Bid Addendum No. 2

Clarkstown Central School District – Masonry Reconstruction & Capital Project Phase 5

CSArch Project No. 151-2101 & 151-2201

This Bid Addendum No. 2 forms part of the Contract Documents and modifies the original bidding documents dated January 13, 2023. Bid Addendum No. 2 consists of (1) cover sheet page and (8) 30X42 drawing sheets.

CNHS
C102

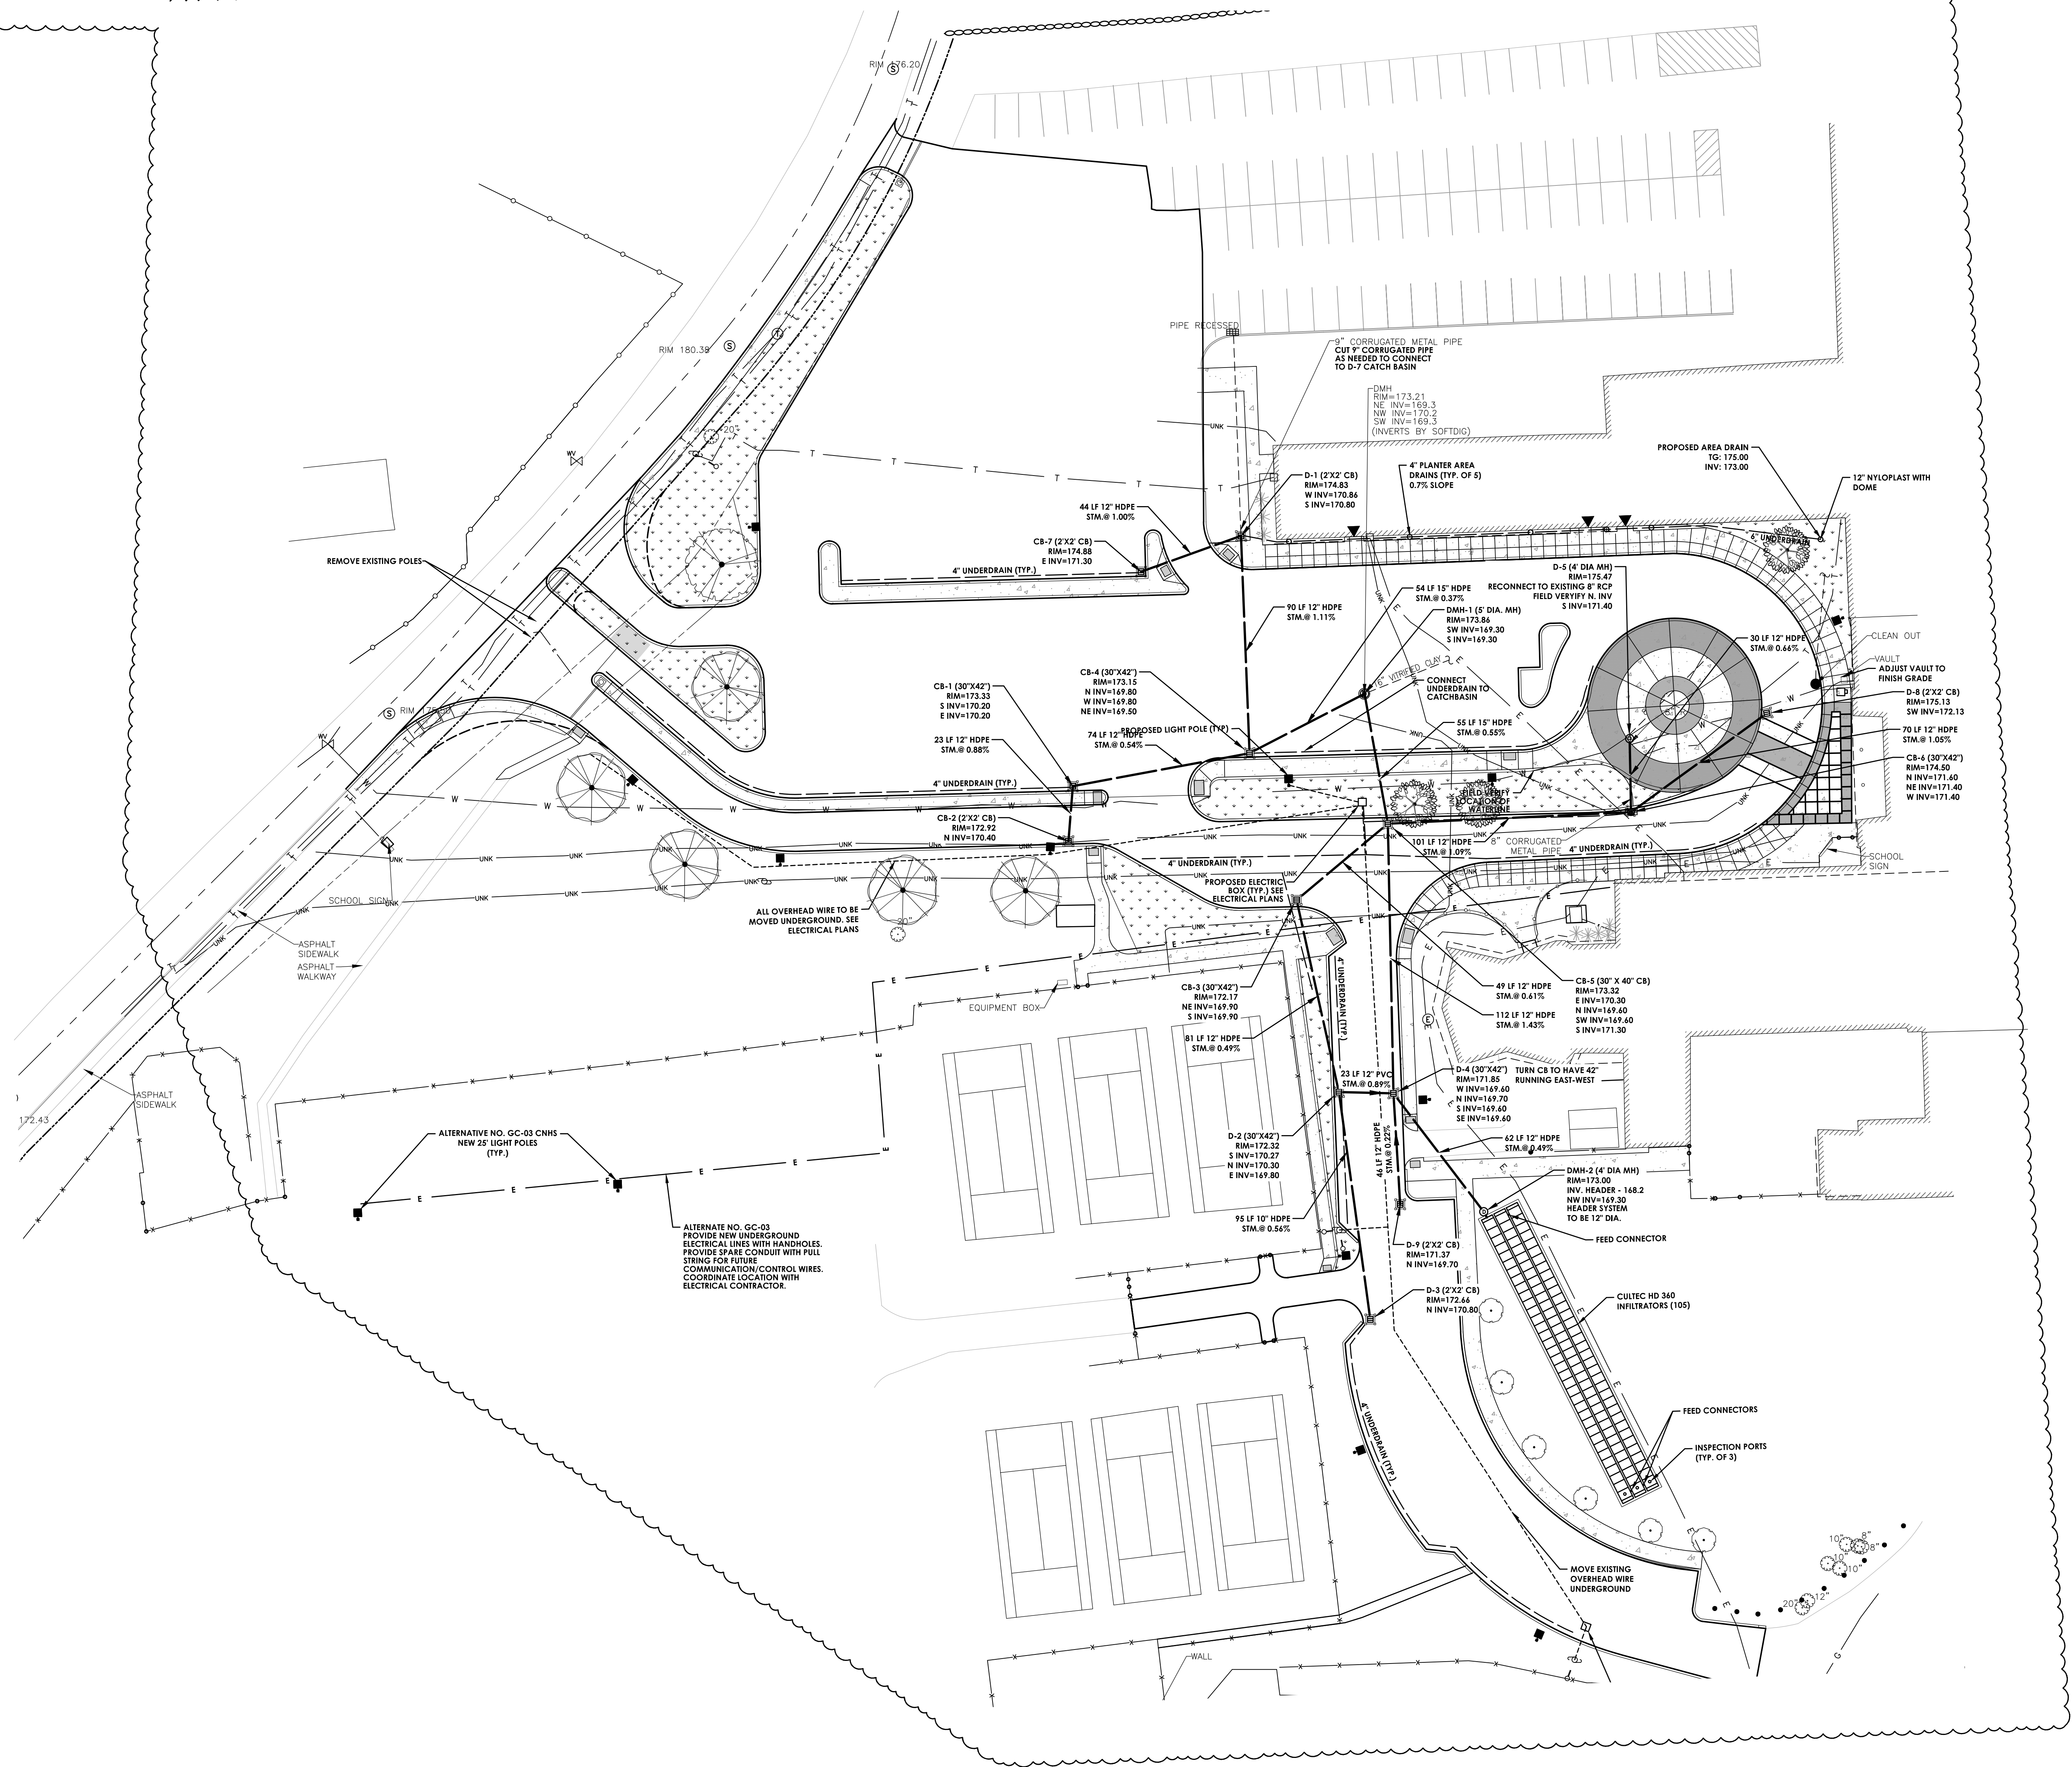
1. ENTIRE C-104 SHEET REPLACED WITH BID ADDENDUM 1 C-104 SHEET.
STORM SEWER SYSTEM REDESIGNED. SEE PLANS FOR CHANGES.
